**THE KENNECOTT EAGLE
MINE PLANNED FOR
UPPER
MICHIGAN IS PREDICTED
TO BE
UNSTABLE.**

AUGUST 2010

JACK PARKER AND ASSOCIATES, INC.

The Kennecott Eagle Project

Figure 1

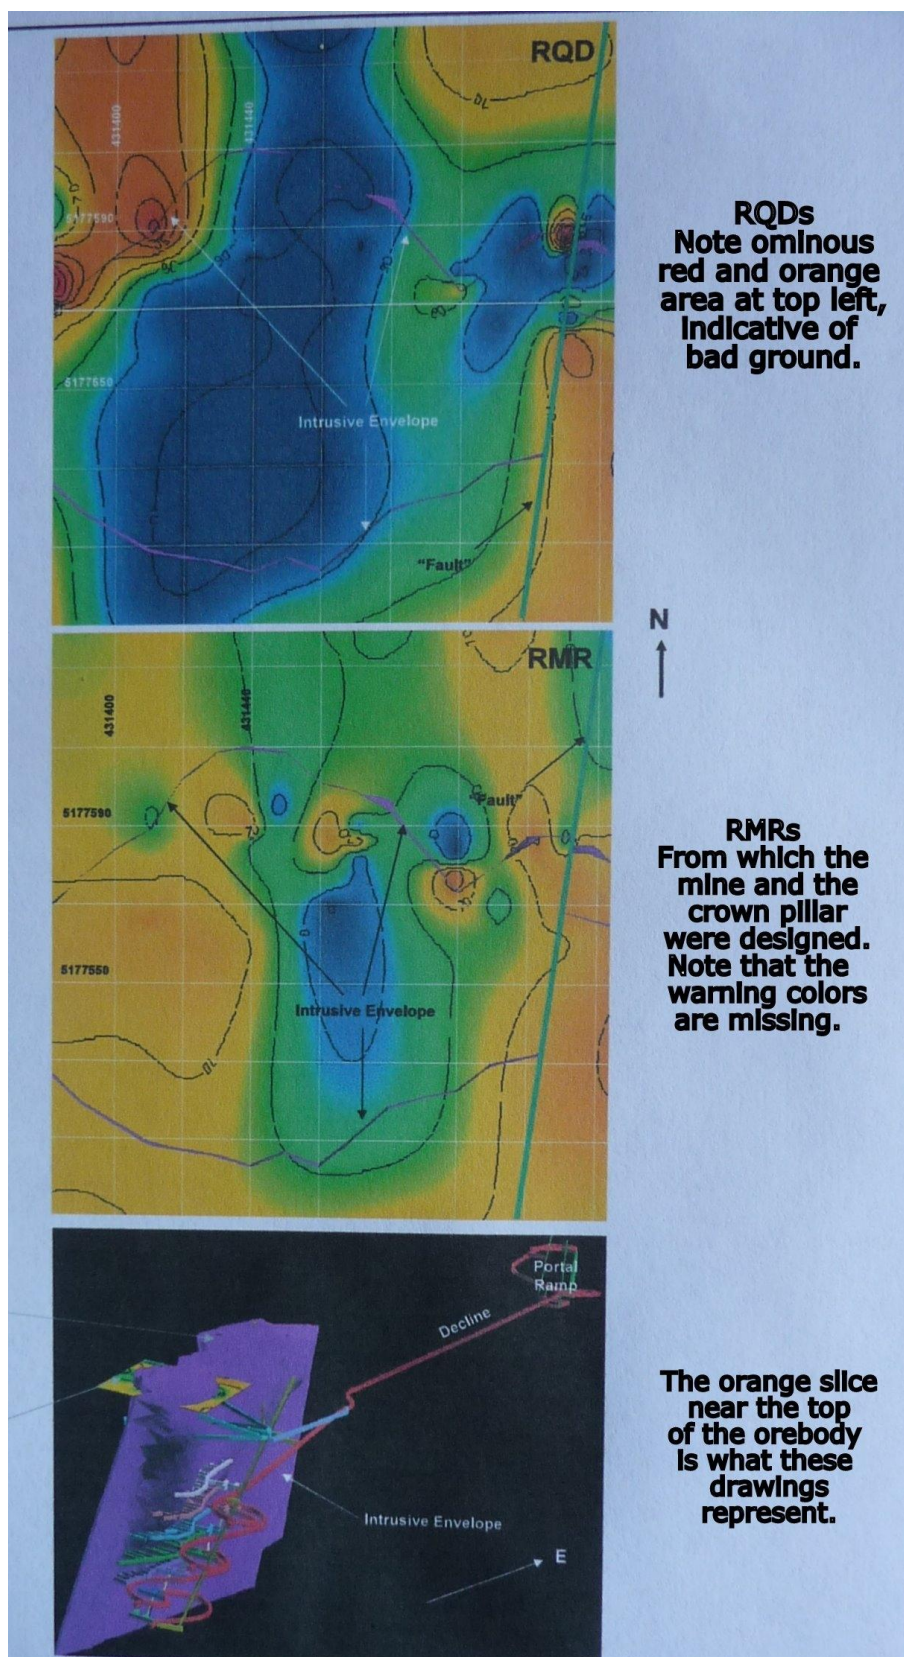
DRAWINGS COMPARING RQDs AND RMRs. Figure 1 is an example. Tabulated values were transferred to drawings at the location of the drill holes. Contours (lines of equal value) were then interpolated between holes. Then the areas between contours were color-coded, from red to show poorest conditions to green and blue showing the best.

Note immediately that the contours around the red holes are close together – “bull’s-eyes” – implying that their influence is local, not widespread. The contours between blue/green holes are far apart, implying that the good conditions *are* widespread. That, of course, skews the information toward favorable conditions.

MOST GRIEVOUS IS THE SYSTEMATIC AND UNFORGIVABLE OMISSION OF LOW-RMR DATA FROM THE DRAWINGS AND THE CONCLUSIONS DEPENDENT ON THEM. THEY HID THE BAD NEWS.

Figure 1 illustrates the point. It represents conditions on a horizontal slice through the ore body, roughly in the middle of the ore body (see lower sketch).

At top left in the upper drawing, RQDs, is a large ominous patch of reds and oranges. This is appropriate, because the cores there are broken and the RQDs are low. Look again at the front cover of this report. Does that look like “solid rock”?

But now look at the middle drawing, RMRs. That ominous red/orange patch does not show up!

Hey! We, like everybody else, had assumed that we were being fed sound engineering information; but now we smell a rat. Existence of the rat was confirmed when we obtained a tabulation of RQDs and RMRs for “our” eight holes. THE LOW RQD VALUES WERE ON RECORD, BUT CORRESPONDING RMRs WERE MISSING. THOSE LENGTHS OF POOR CORE HAD BEEN OMITTED AS IF THEY DID NOT EXIST. MINE PLANNERS, REGULATORS AND OUTSIDE REVIEWERS ALIKE DID NOT NOTICE THE DECEPTION. It is subtle and clever, although not especially smart.

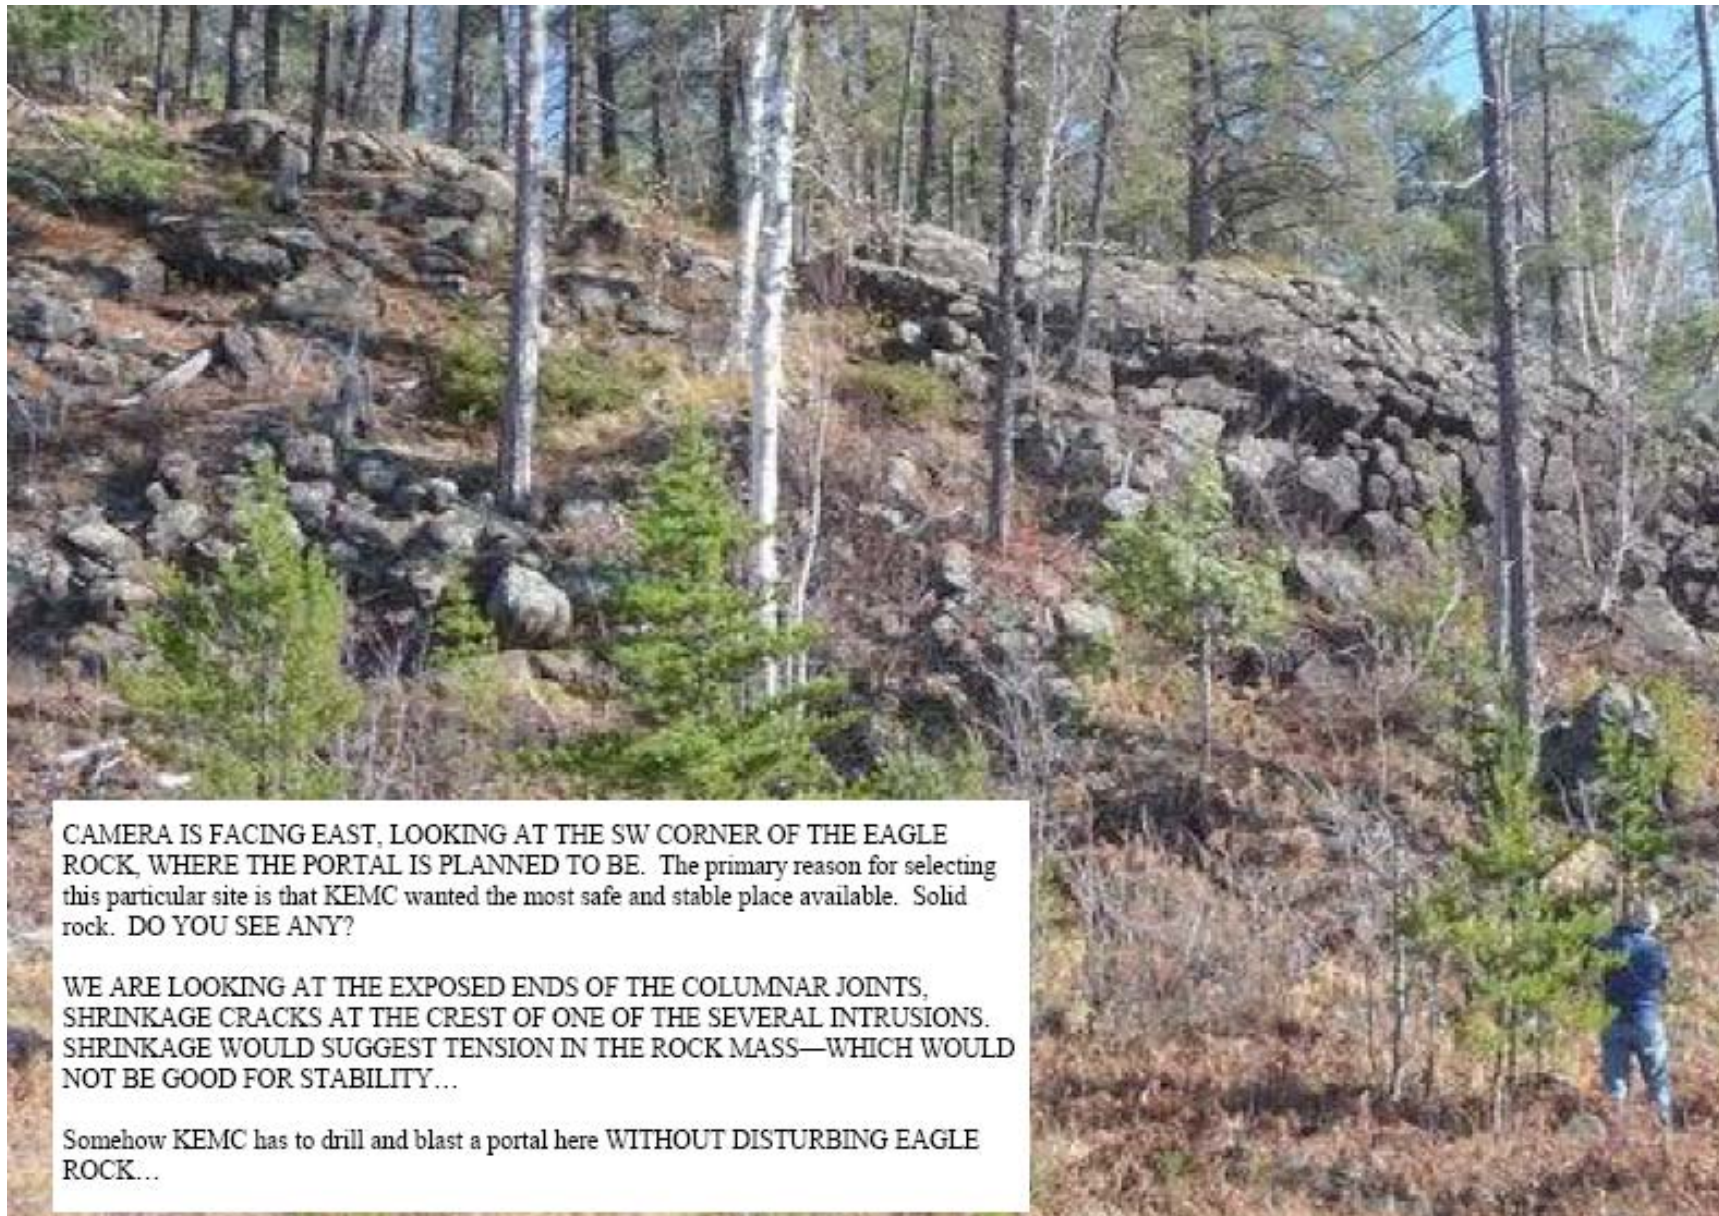
CAMERA IS FACING EAST, LOOKING AT THE SW CORNER OF THE EAGLE ROCK, WHERE THE PORTAL IS PLANNED TO BE. The primary reason for selecting this particular site is that KEMC wanted the most safe and stable place available. Solid rock. DO YOU SEE ANY?

WE ARE LOOKING AT THE EXPOSED ENDS OF THE COLUMNAR JOINTS, SHRINKAGE CRACKS AT THE CREST OF ONE OF THE SEVERAL INTRUSIONS. SHRINKAGE WOULD SUGGEST TENSION IN THE ROCK MASS—WHICH WOULD NOT BE GOOD FOR STABILITY...

Somehow KEMC has to drill and blast a portal here WITHOUT DISTURBING EAGLE ROCK...
